New York Power  
Authority

April 1, 1992  
JPN-92-018

Subject: James A. FitzPatrick Nuclear Power Plant  
Docket No. 50-333  
Station Blackout Rule  
Response to Safety Evaluation Recommendations

Additional Responses to Safety Evaluation Recommendations

Penetration Number 39A,B

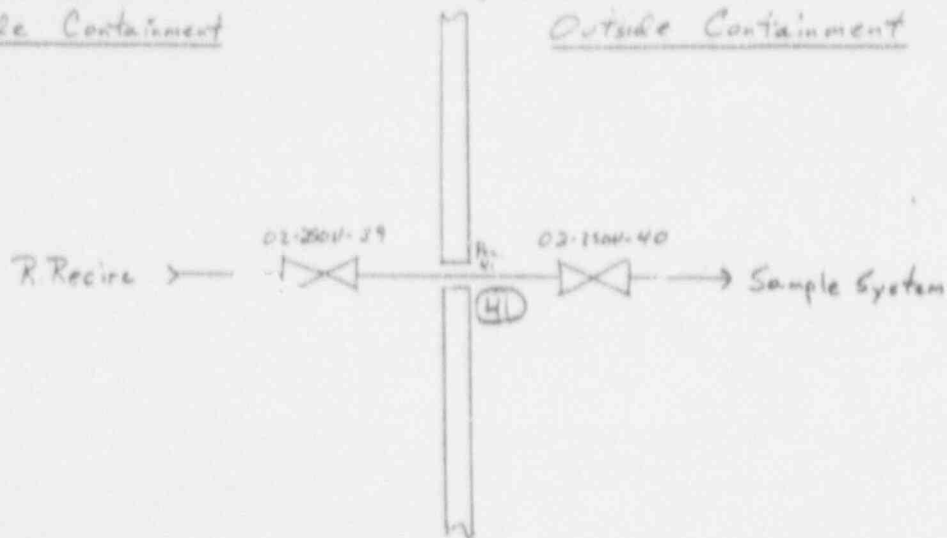
2.2.5 Containment Isolation

*Add the valves that were excluded by the additional criteria (a valve interlocked with another valve) in an appropriate procedure.*

*Identify actions which are needed to confirm these valves (interlocked valves excluded by methodology) are closed. The valve closure needs to be confirmed by position indication (local, remote, mechanical, process information, etc.) independent of the preferred (off site) or on site power.*

Penetrations 39A,B are for the drywell spray lines supplied from the residual heat removal (RHR) system. Isolation of these lines is provided by ac motor operated valves 10MOV-31A,B and 10MOV-26A,B. Therefore, these valves would become inoperable during an SBO event. However, each pair of valves (10MOV-39A and 10MOV-26A) and (10MOV-39B and 10MOV-26B) are electrically interlocked and mounted in series. The interlocks insure that one valve is always closed except during drywell spray operations. Drywell spray requires operation of a key lock switch in the control room and a high drywell pressure signal to override this interlock.

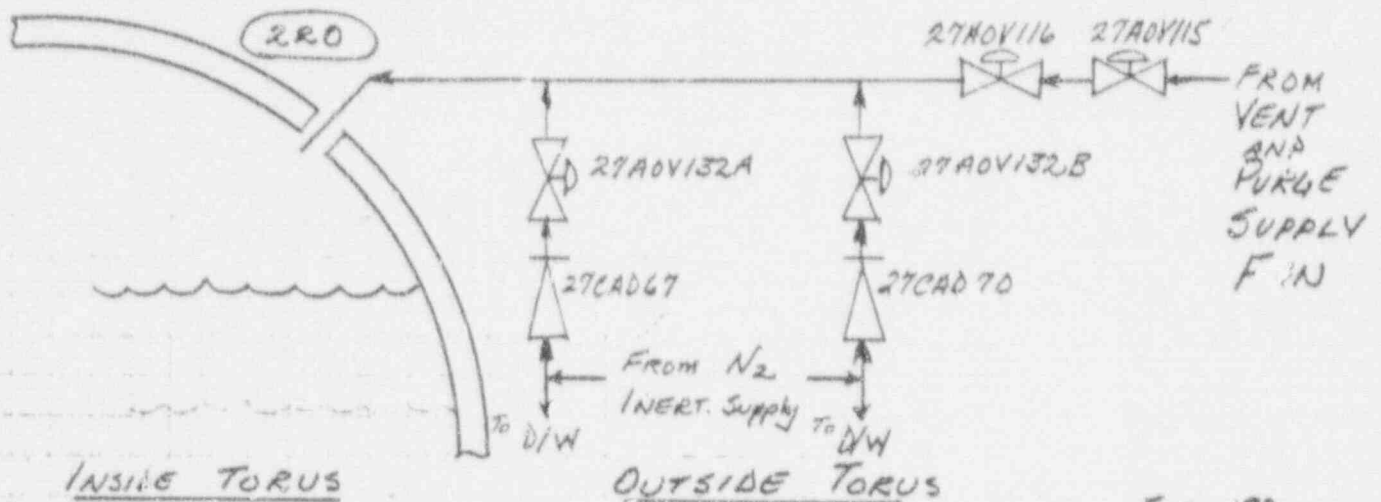
*In addition, the licensee should verify that the fail closure of the drywell and torus pressure sensing penetration valves would not cause the loss of pressure indications in the control room for these areas.*

These two pressure sensing lines are used only for the integrated leak rate testing (ILRT) instrumentation. They do not provide information to the operator during normal operation nor during an SBO. Therefore, isolation of these lines during a station blackout event is acceptable. Control room primary containment pressure instrumentation is served by penetration number 50c "Instrumentation Sensing DW Pressure". Penetration 50c is shown as "typical" and the listed characteristics of the penetration also apply to the instrumentation line penetrations for control room indications of containment pressure.

As a part of the July 1992 update of the FSAR, the Authority will add notations to FSAR Table 7.3-1 in the "Remarks" column to indicate that these two lines are used only for ILRT testing.
